SUBDIVISION REVIEW SHEET

CASE NO.: C8-2022-0254.0A

SUBDIVISION NAME: 1191 Ridge Drive Subdivision

**CITY OF AUSTIN –DEVELOPMENT SERVICES DEPARTMENT
SUBDIVISION APPLICATION – MASTER COMMENT REPORT**

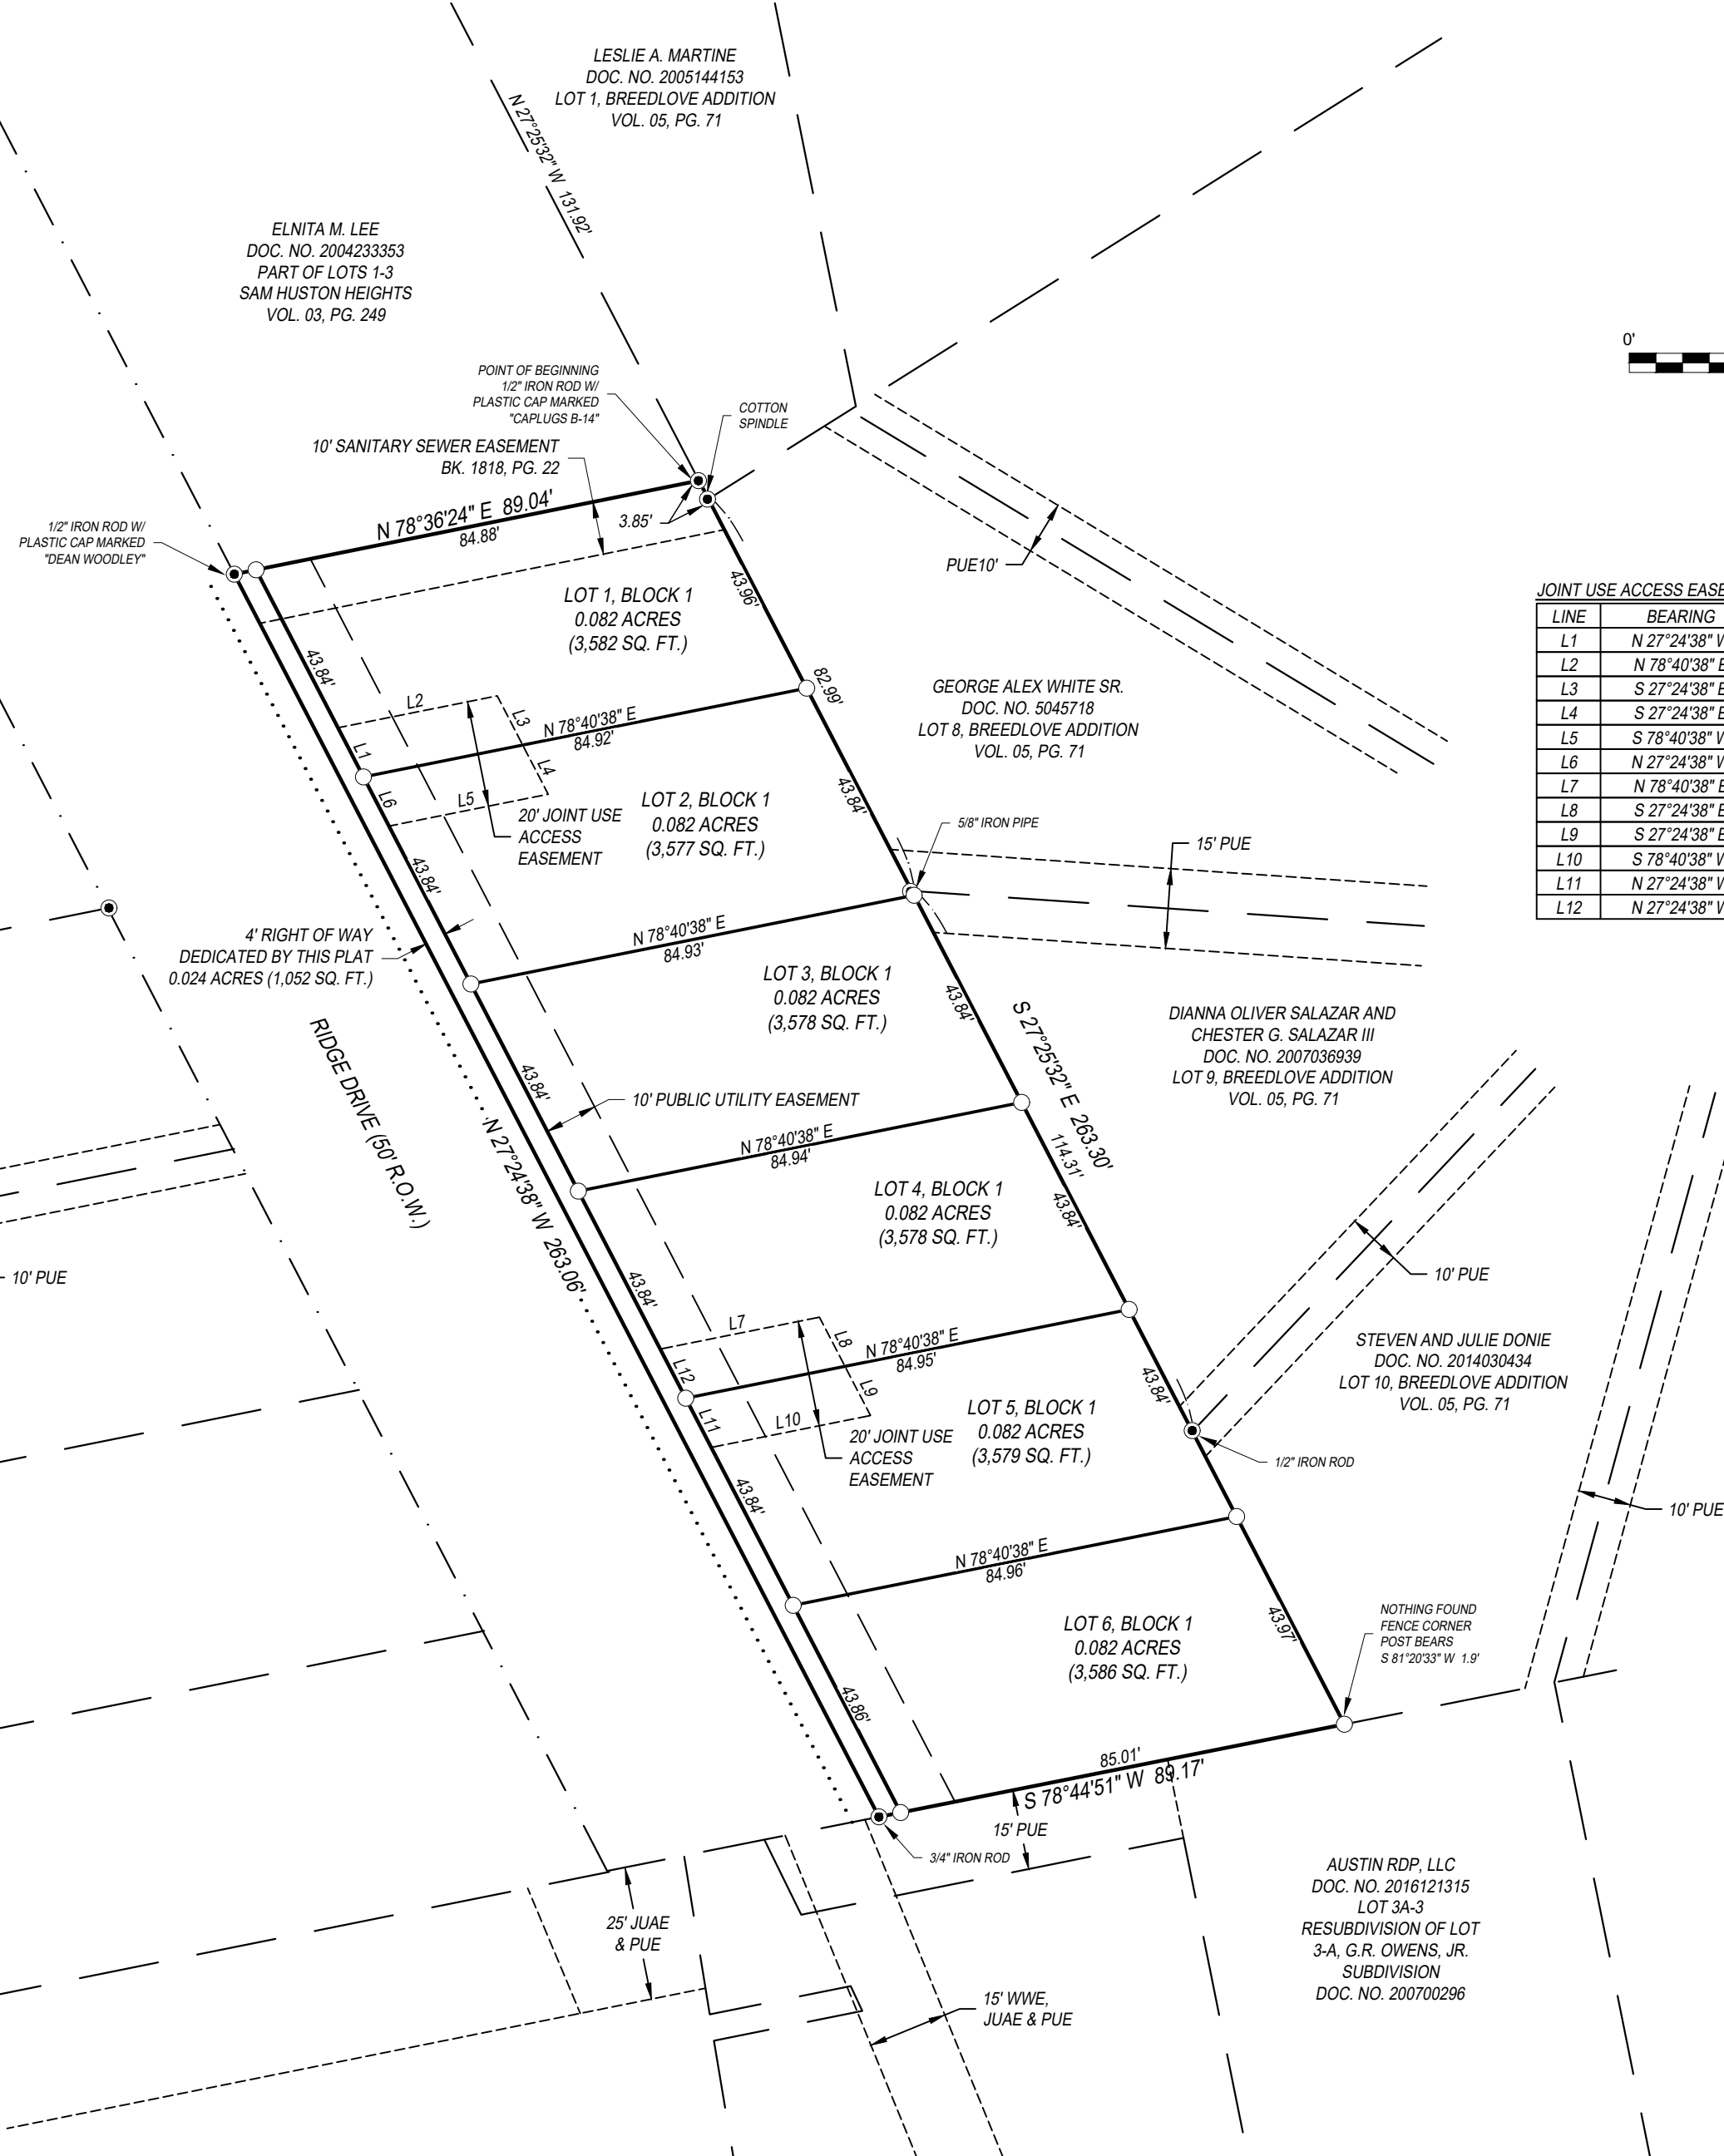
EL 1. U1: **Comment stands.** Please label 10' easement adjacent to Ridge Dr as an **electric distribution, electric telecommunications, and electric fiber easement**, not a public utility easement. If this is a conflict please email Cody.Shook@austinenergy.com to discuss. [LDC § 25-4-132 - EASEMENTS AND ALLEYS.](#)

ATD 4. Per Engineering Summary Letter all 6 proposed lots will have access to Ridge Drive through individual or **joint-use driveways**.

Please, show the joint use access easements on the plat (if proposed).

SR 3. **Update 1:** the case number on the lower right margin of each sheet, C8-2022-0254.0A . LDC 25-1-83, 30-1-113

SR 5. Provide Lot Summary Table, the table should include lot acreages, square footage, and totals. LDC 25-1-83, 30-1-113

Update 1: Label the lot summary table as Cottage Lot Summary Table.

U1: Is there no driveway proposed for the southern most lot? This could affect the payment in lieu calculations.

U1: Comment cleared.
